PLAN REVIEW SHEET

Date:	01/09/2009	Staff Contact:	David McDonald
Petitioner:	North Davidson Acquisitions	Telephone:	704-336-6900
Petition:	2008-004	Fax:	704-432-1277
		Email:	dmcDonald@ci.charlotte.nc.us
Location:	+/- 3.87 acres Northeast corner N. Davidson St and E. 36t St.	Attachments:	Shelter_Concrete_Standards.pdf (See 60.03A)
Existing Zoning:	NS, O-2 and R-5 Commercial Retail, Residential, Parking		
Requested Zoning:	MUDD-O (Development of up to 200k/sf multifamily & up to 60k/sf commercial space, not to exceed 225 residential units)

SECOND SUBMITTAL

STD. NO.	REV.
60.03A

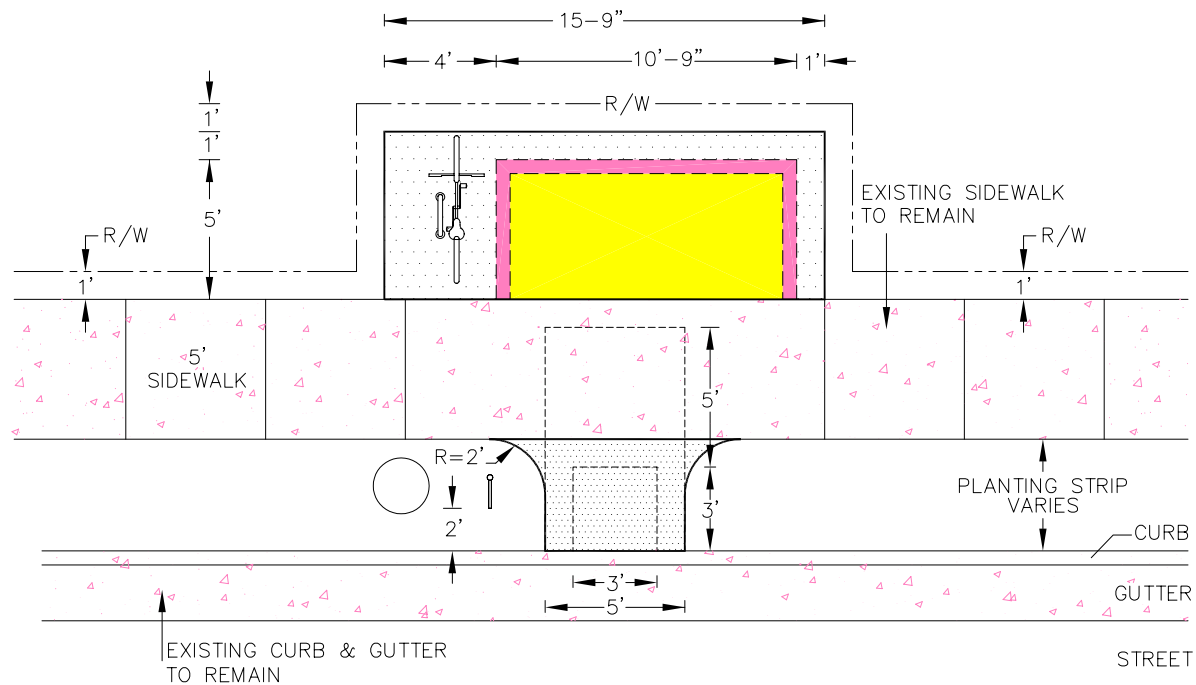
- 1) The petitioner's site is currently served on 36th Street by Route 3 Plaza Road and Route 23 Shamrock Drive.
- 2) The amended site plan does not appear to include the CATS rezoning request for the petitioner to construct a shelter pad to be located on 36th St. approximately 60' North of the intersection of 36th St. and Alexander St., constructed to CATS Development Standards 60.03 A (see attached).
- 3) CATS requests the petitioner to please designate such in the revised site plan and/or accompanying notes.

Please contact Leonard Ganther (CATS Operations) @ 704.432.1283 prior to demolition or construction, to coordinate the final location of the new shelter pad.
